Access Compliance Report

Public Rights-of-Way

Intersection ID: 10031761	Main Street: MIDWAY_PARK_DR	Cross Street: N/A	Location:	E
ADA ID: F76CC6A526D3	Ramp Type: Perp	Initial Pass/Fail: Pass	Overall Compliance: No	Severity Score: 30

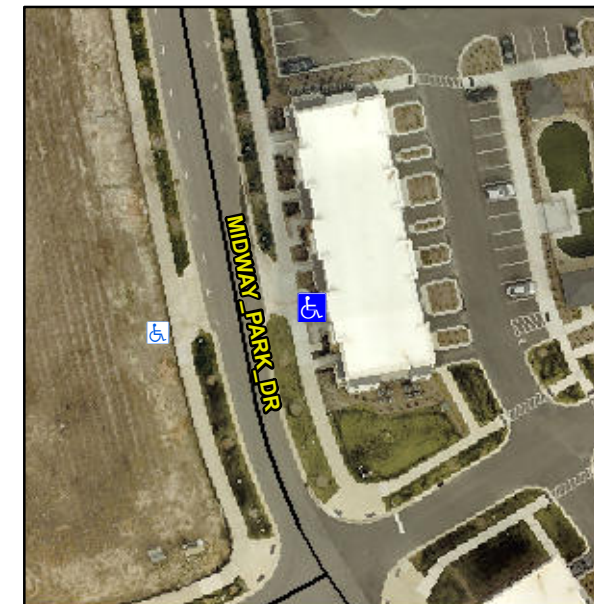
**R304.2.2-Perp, R304.3.2-Para,
R304.2.3, R305, R302.7.2**

Compliance	Description	Data	Compliance	Description	Data
N/A	Ramp Length (in)	47.0	Yes	Ramp Slope (%)	6.1
Yes	Ramp Width (in)	71.0	Yes	Ramp XSlope (%)	0.4
No	Flare Type	Curbbed_WithWalkSurface	Yes	Flare Type RT	N/A
No	Flare Slope LT (%)	N/A	N/A	Flare Slope RT (%)	N/A
N/A	Flare Traversable LT?	No	N/A	Flare Traversable RT?	No
Yes	Landing Length (in)	95.0	No	DWS Provided?	No
Yes	Landing Width (in)	100.0	N/A	DWS Contrast?	No
No	Landing Slope (%)	2.7	N/A	DWS Length (in)	N/A
Yes	Landing X Slope (%)	1.8	N/A	DWS Full Width?	No
N/A	Landing Curb? (Y/N)	No	N/A	DWS Offset (in)	N/A
N/A	Shared Landing?	No			
Yes	Gutter Ponding?	No	Yes	Gutter Slope (%)	2.1
No	Gutter Lip Ht (in)	1.5	Yes	Gutter X Slope (%)	1.1
N/A	Painted X Walk1?	No	N/A	Painted X Walk2?	N/A
	X Walk 1 Direction	To W		X Walk 2 Direction	N/A
N/A	X Walk 1 Width (in)	N/A	N/A	X Walk 2 Width (in)	N/A
	X Walk 1 Slope (%)	2.8		X Walk 2 Slope (%)	N/A
	X Walk 1 X Slope (%)	1.5		X Walk 2 X Slope (%)	N/A

**Remove & Replace Entire Ramp.
Grind Gutter Lip.**
